Comments on Detrex's Source Remedy Modification and DS Tributary Excavation Work Plans

**Fields Brook Superfund Site
Ashtabula, Ohio**

June 27, 2011

FIGURE
2

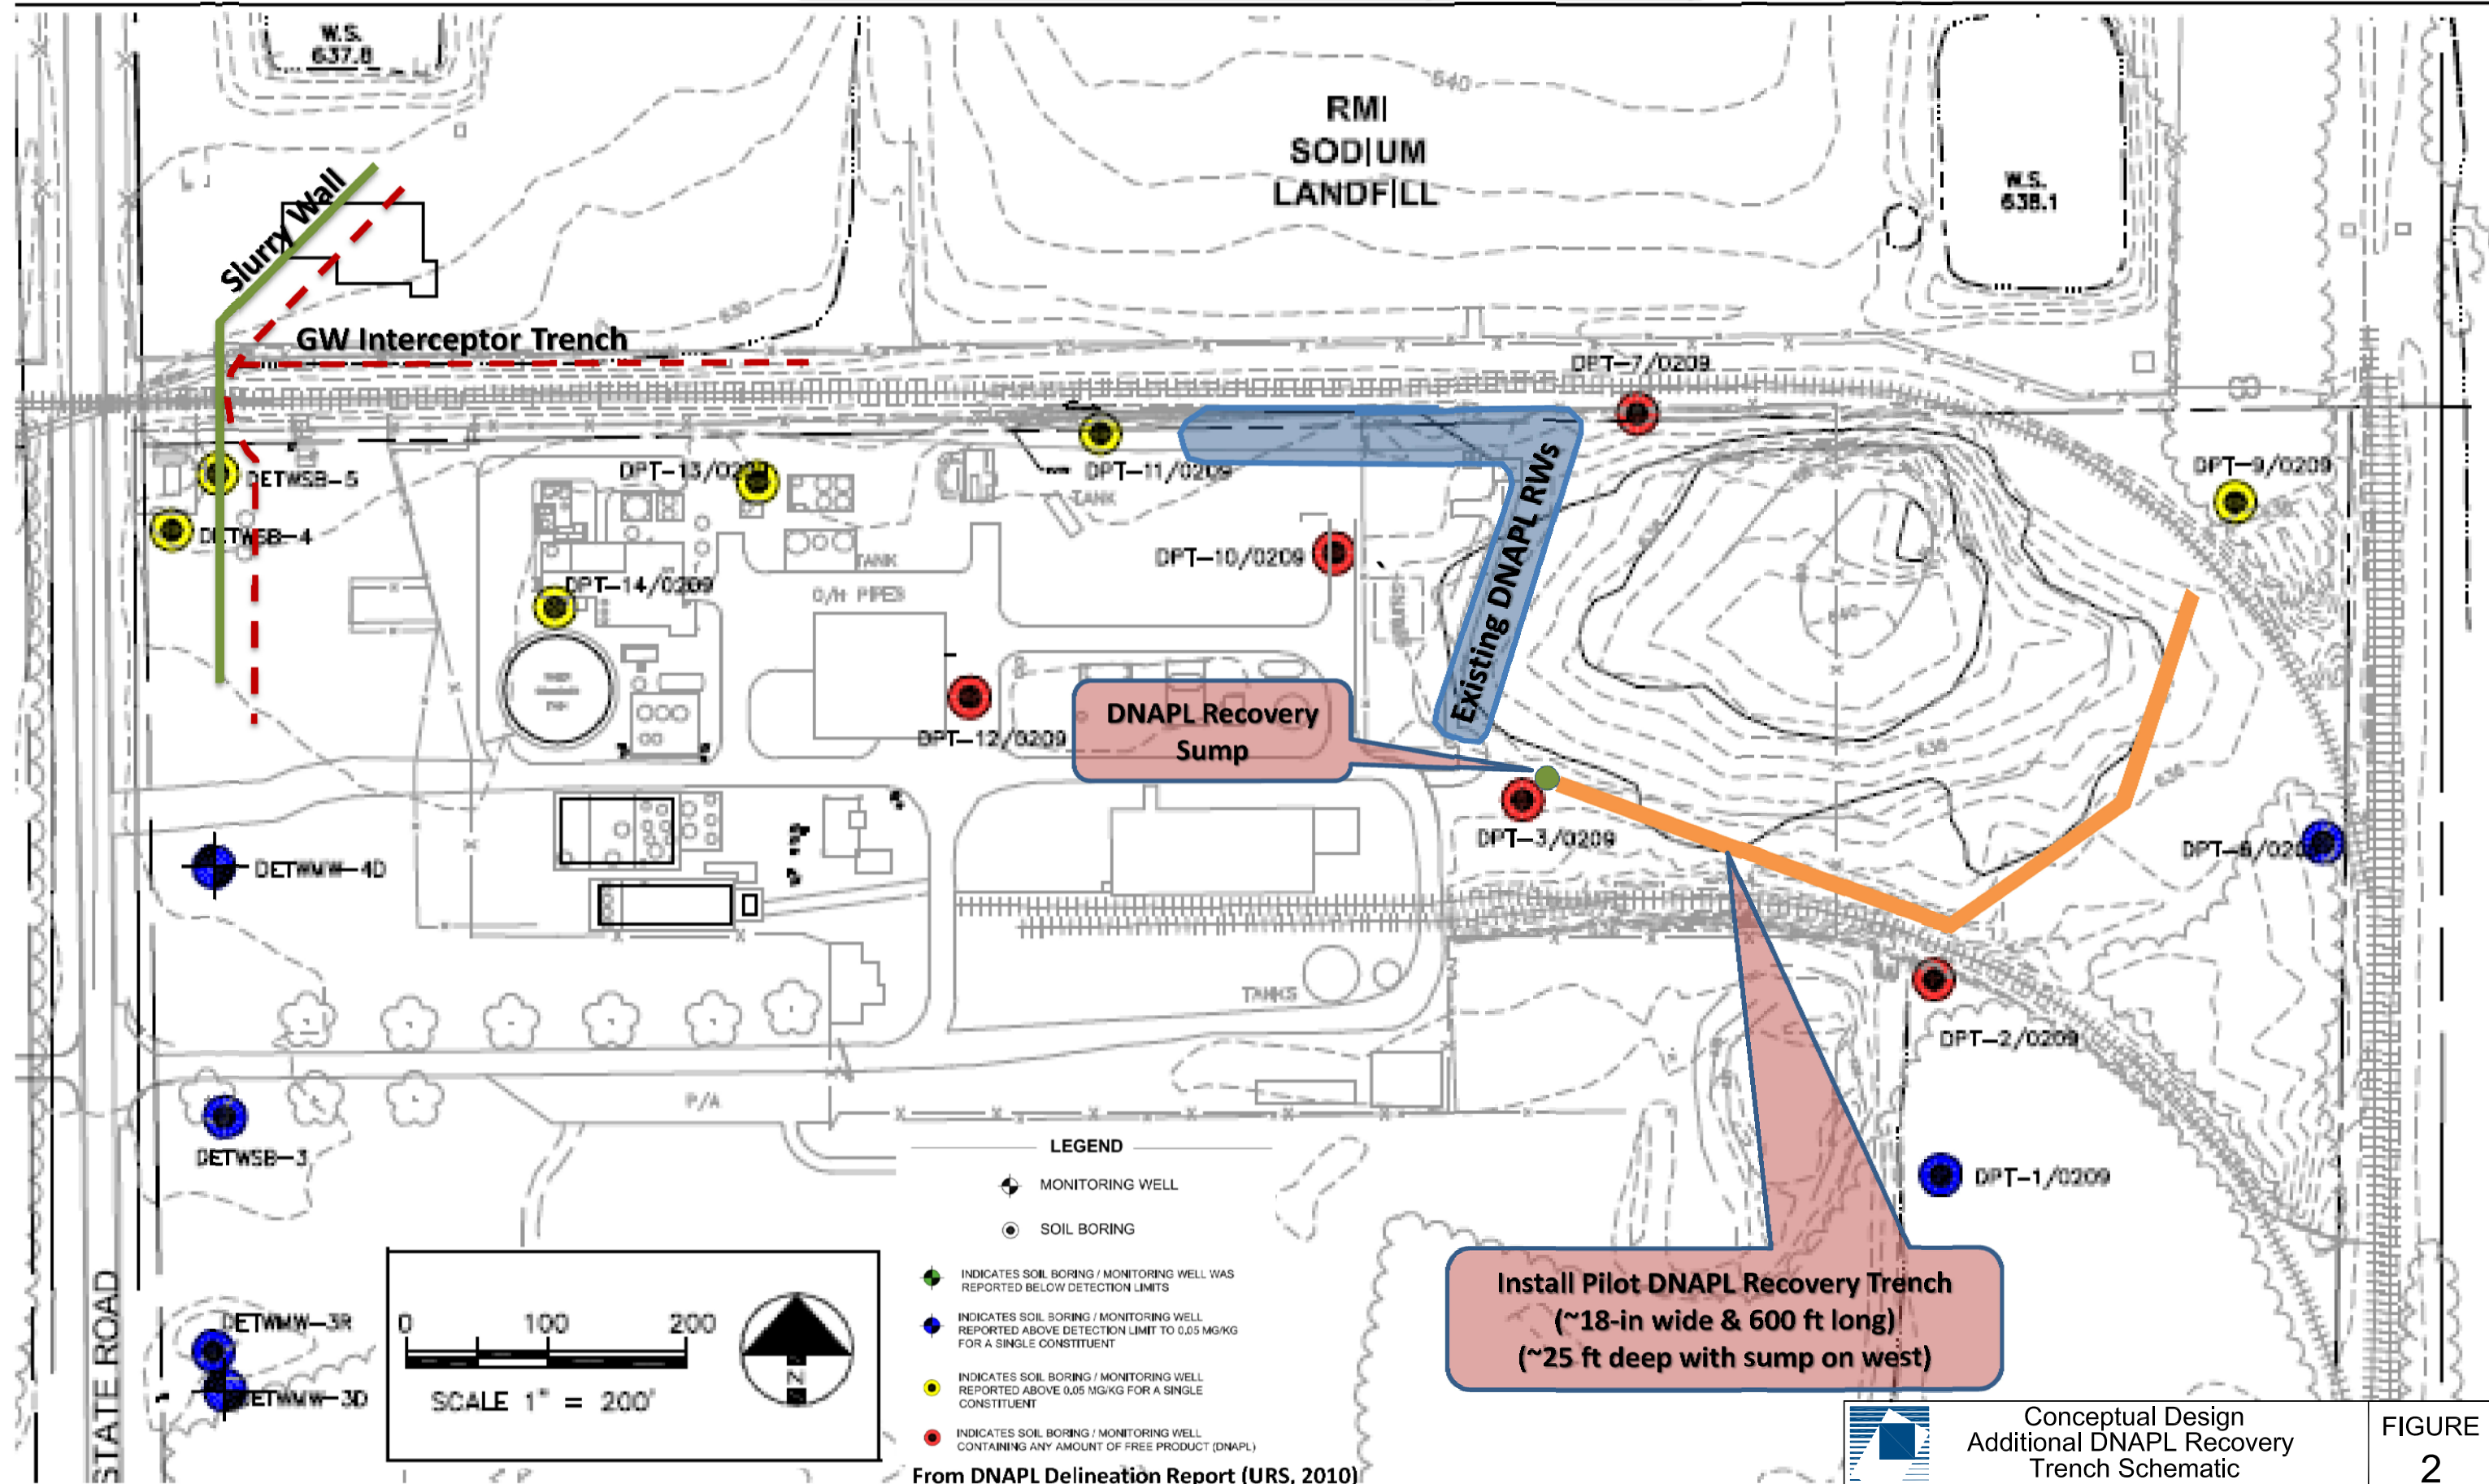
As previously discussed, Detrex is proposing to install a 600 foot long, passive, DNAPL collection trench along the southern and eastern edge of the former lagoon area (Figure 2). The proposed trench will be approximately 28 to 30 feet deep, 1.5 feet wide, and backfilled with granular material. The trench will be sloped to drain to a single sump, where DNAPL accumulation will be manually monitored, and collected liquids will be pumped out (URS, 2011a).²

The current Detrex deep trench proposal is even more passive (*i.e.*, even more inefficient) than the deep trench alternative that was previously rejected in the ROD. Alternative IIB in the ROD utilized submersible pumps to remove DNAPL and groundwater. The current proposal includes one sump, manual DNAPL thickness measurements, and no clearly enumerated procedures for DNAPL and contaminated groundwater removal. As stated in (b) above, the deep trench remedy proposed by Detrex fails to meet the remedial objectives specified in the ROD – a reason that this alternative was previously considered and rejected in the ROD. Departure from the previously approved remedy to allow implementation of the Detrex deep trench proposal will require a ROD amendment or ESD. For all the reasons US EPA stated in the ROD, such a ROD amendment or ESD would not be justifiable.

FIGURE
4

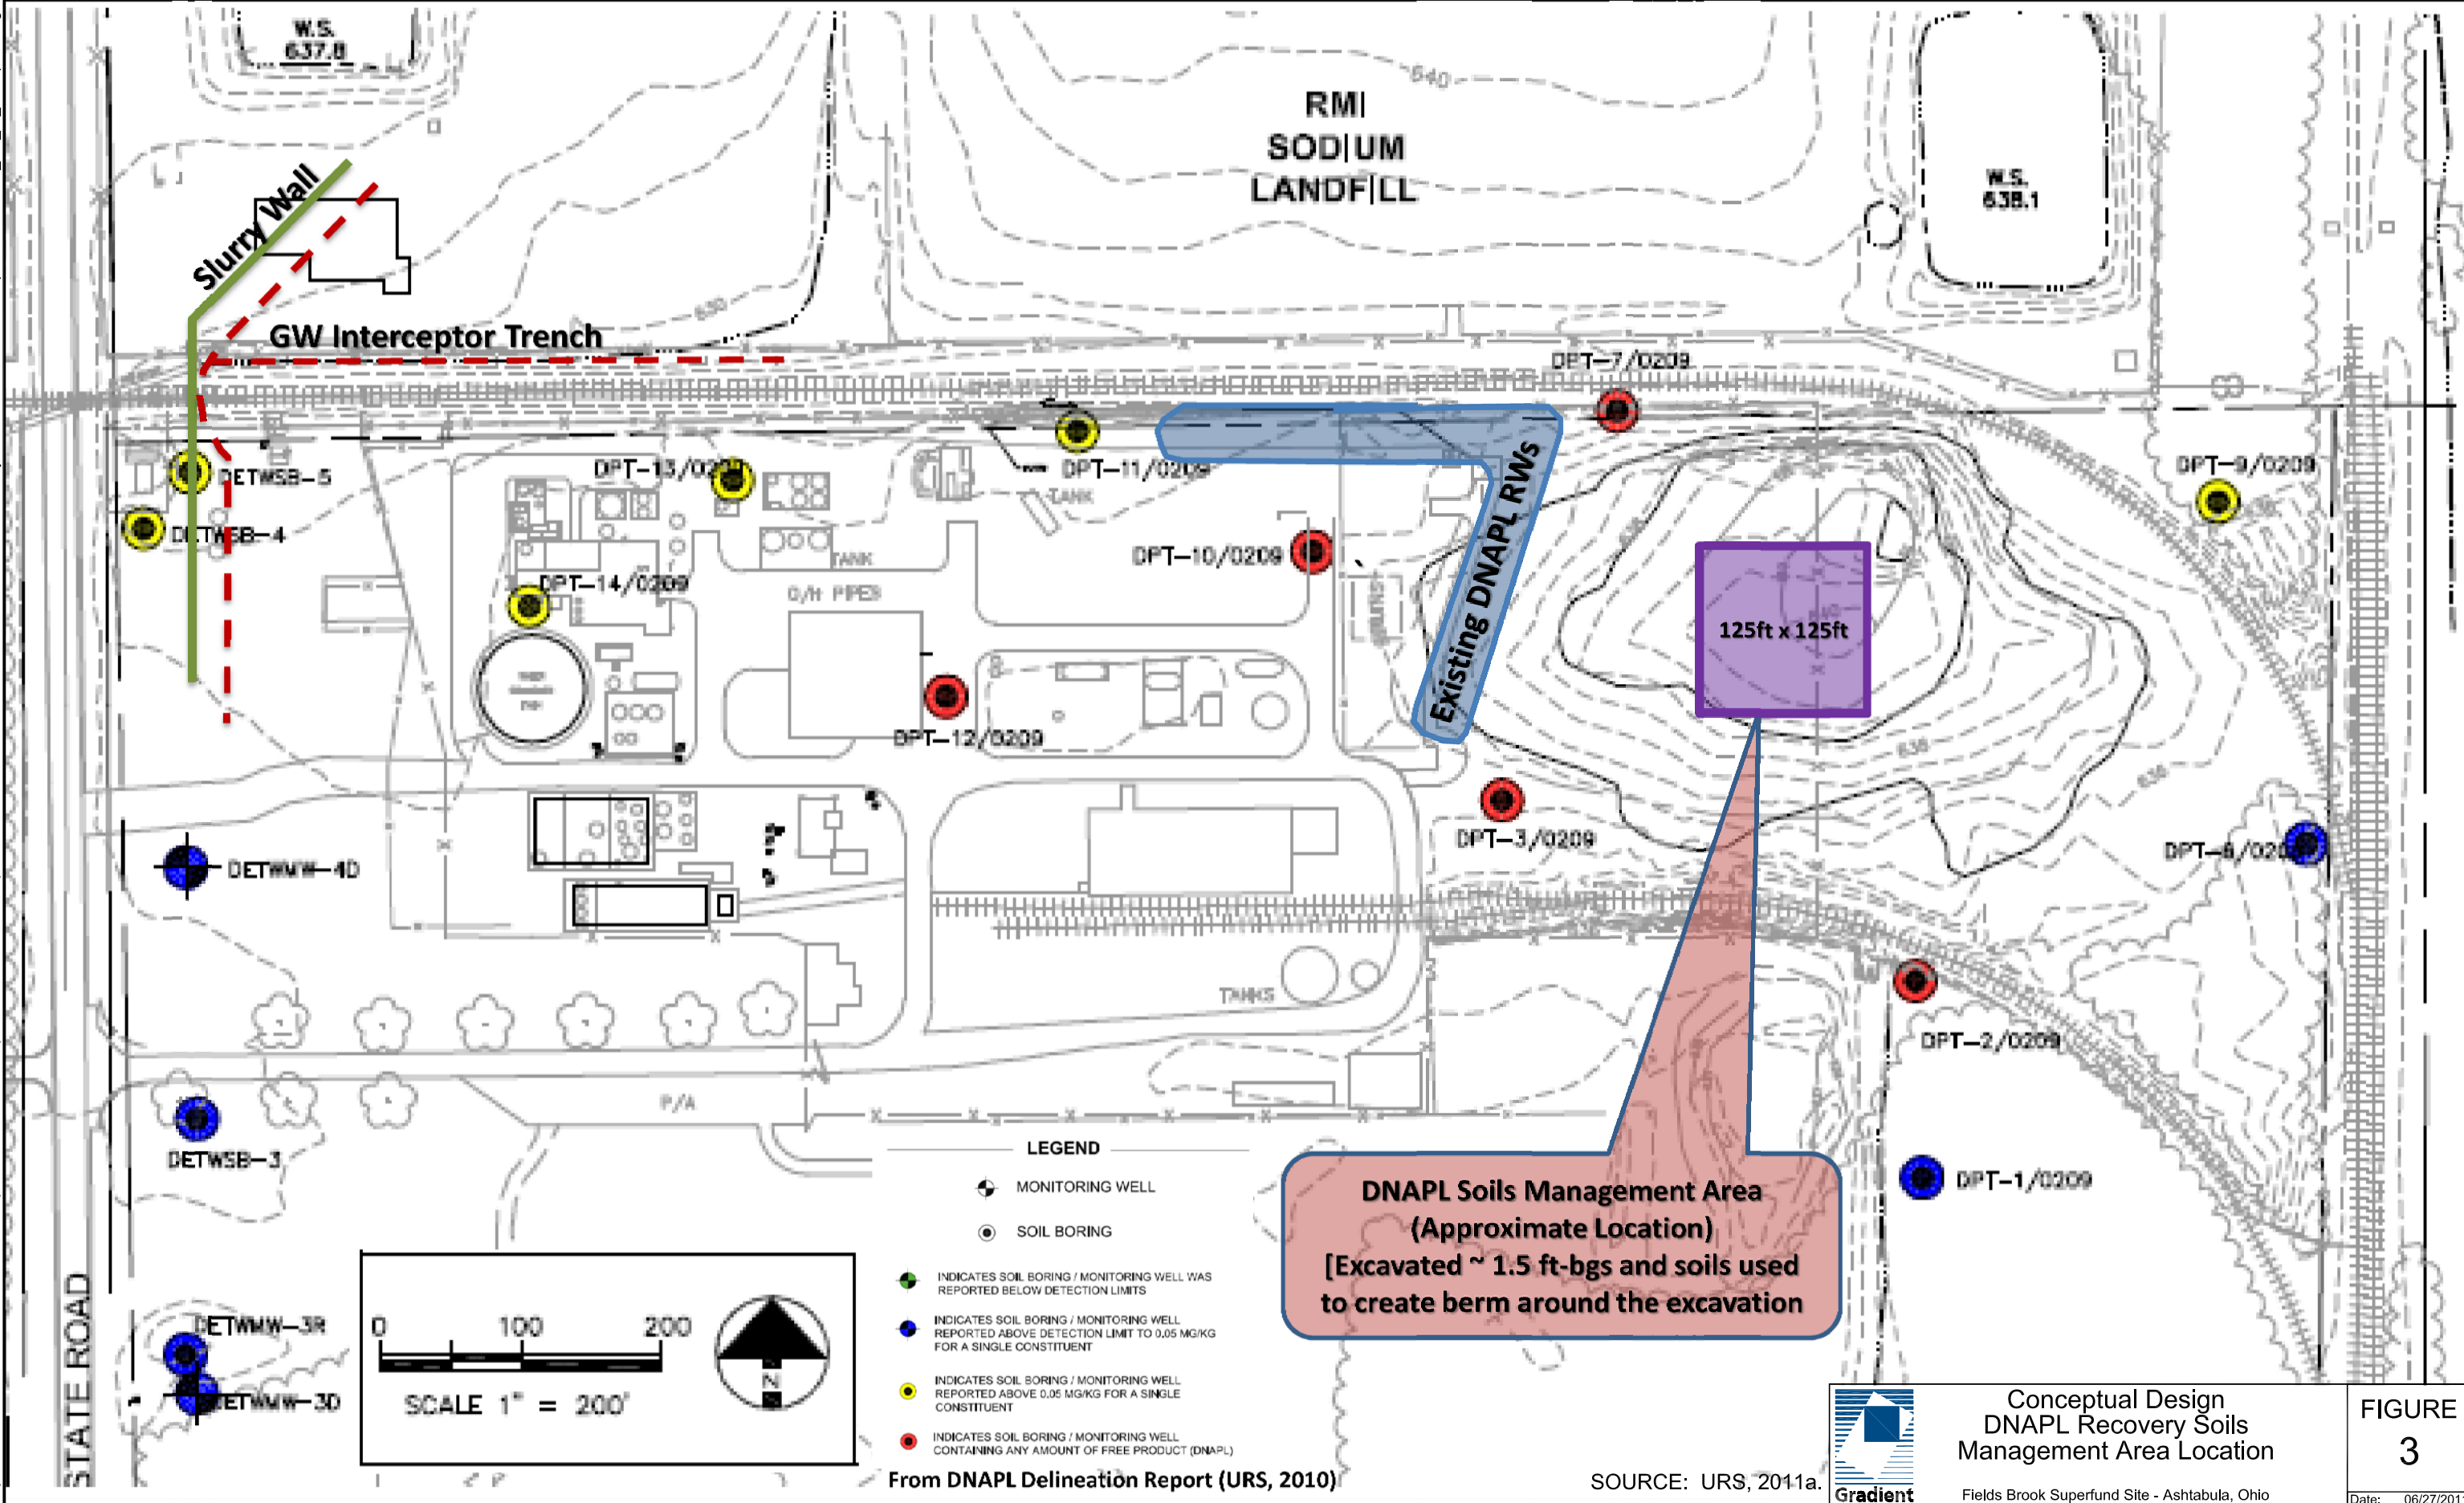
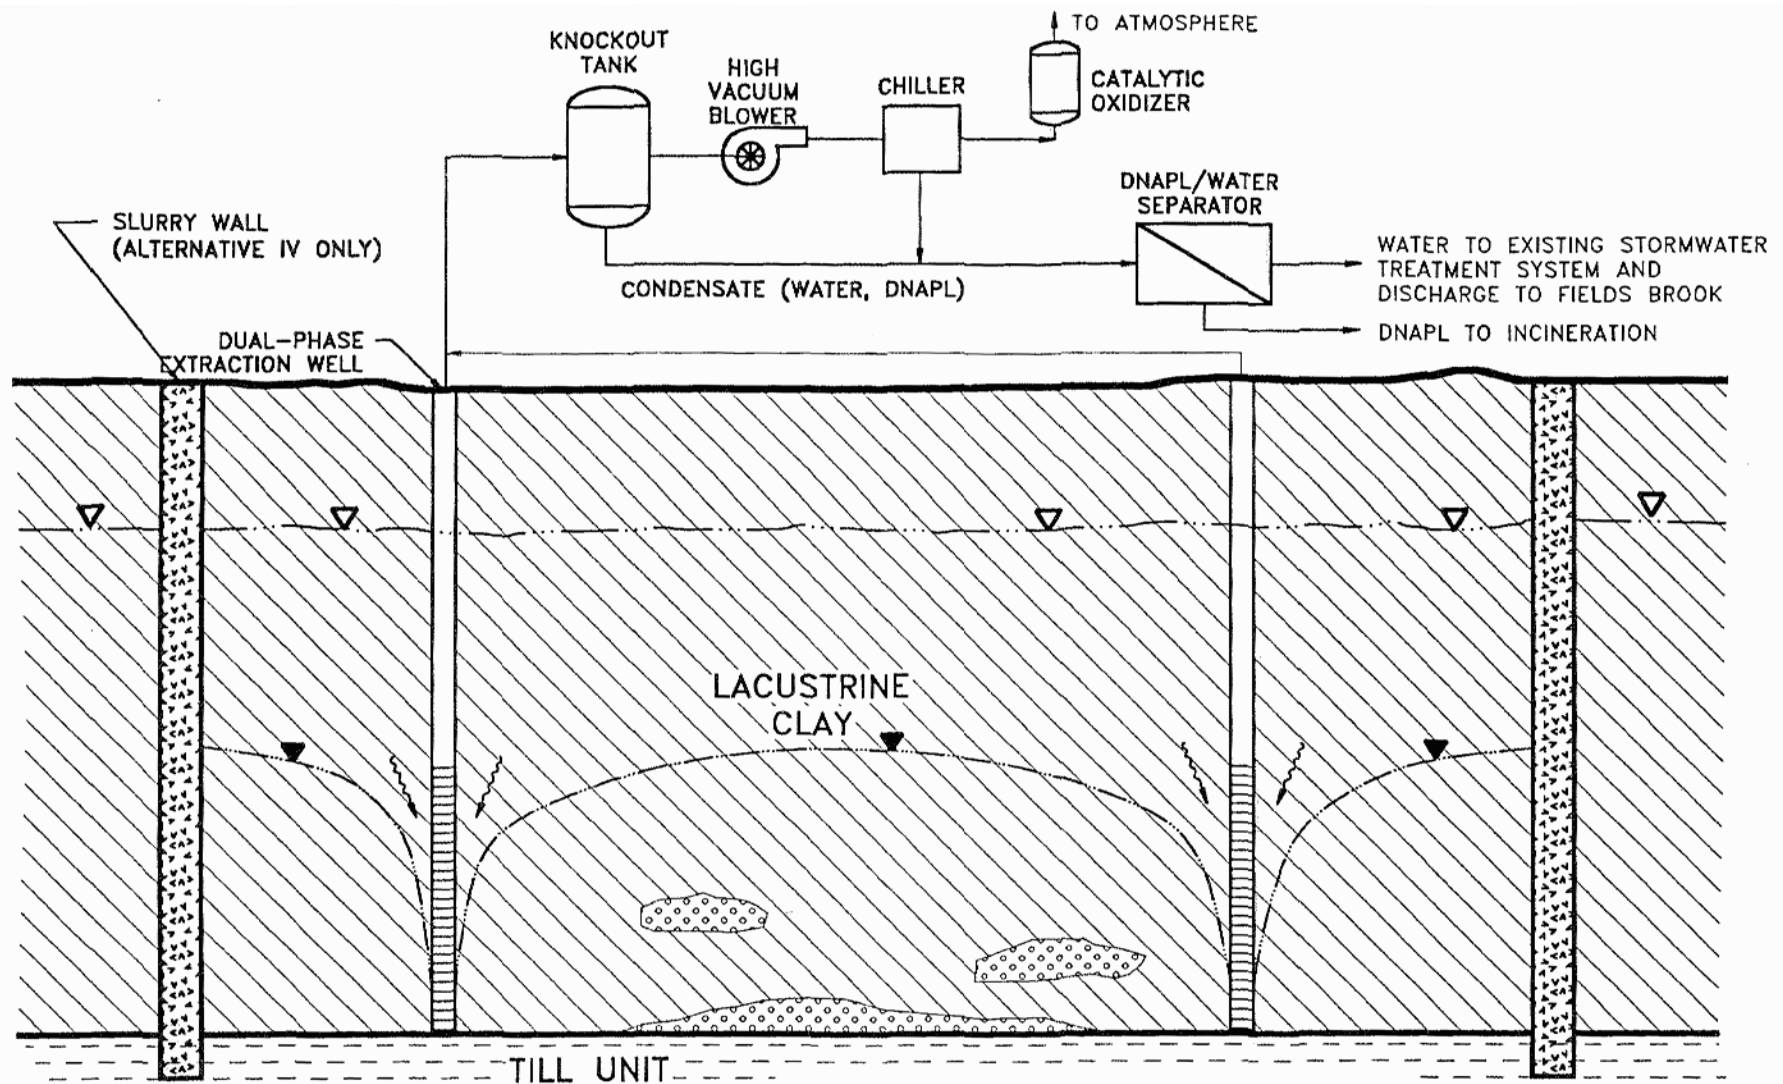
As indicated in a schematic for vacuum-enhanced extraction in the SCOU Feasibility Study (WWC, 1995; see attached Figure 4), one of the key reasons for selecting vacuum-enhanced extraction as the preferred remedy was that it would induce DNAPL constituents to flow *via* all phases (vapor, dissolved, and free phase) into the recovery wells, regardless of the depth at which the DNAPL material was present. Detrex, by contrast, is proposing DNAPL recovery wells that will be screened at the base of the lacustrine clay (5 foot screen, with the screen bottom located at a depth of 15 to 25 feet below ground surface) and will only passively collect mobile DNAPL. Prior investigations conducted at the Detrex Facility have encountered DNAPL and/or soil concentrations indicative of DNAPL at shallow depths. For example, the log for boring DETSB15 indicated the presence of DNAPL at 5 to 7 feet below ground surface. The proposed well design would not intercept such DNAPL since the proposed well screens are too deep, especially given that no vacuum will be applied to induce DNAPL migration to the recovery well.

Figure 1
DNAPL Thicknesses Observed in Detrex Source Control Monitoring Wells
Detrex Facility, Fields Brook Superfund Site, Ashtabula, OH

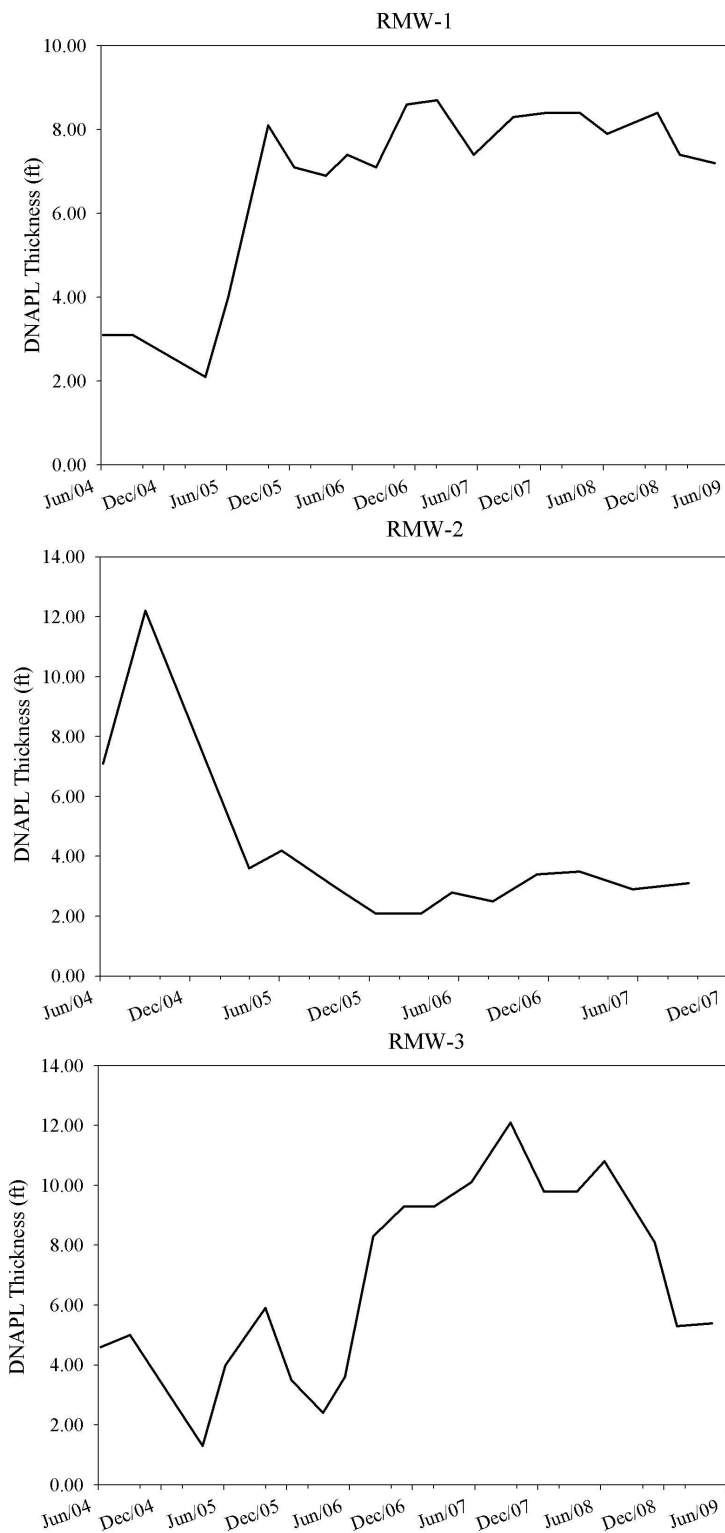
The system has recovered 15,680 gallons of DNAPL as of April 2009, a remarkably large volume, given the limited scale of the system and the inefficient manner in which it is being operated. However, DNAPL thicknesses have not declined appreciably since system operations began and DNAPL continues to flow into the wells (Figure 1). These findings are important for two reasons:

- First, continued DNAPL accumulation in wells is clear, indisputable indication of its subsurface mobility. Furthermore, DNAPL migration into the pilot system's area of influence, only a small fraction of the larger plume area, causes major concern over the fate of the mobile DNAPL beyond the area of influence of the extraction wells.
- Second, the collection of this volume of DNAPL in a poorly designed, sub-optimally operated pilot-scale system is clear indication of the vast DNAPL reservoir (previously estimated to be at least 250,000 gallons) that remains at the Detrex facility. In addition, these DNAPL recovery data demonstrate that much higher DNAPL recovery, a critical component of effective source control, can be achieved at the Detrex site using a properly designed, installed and operated system.
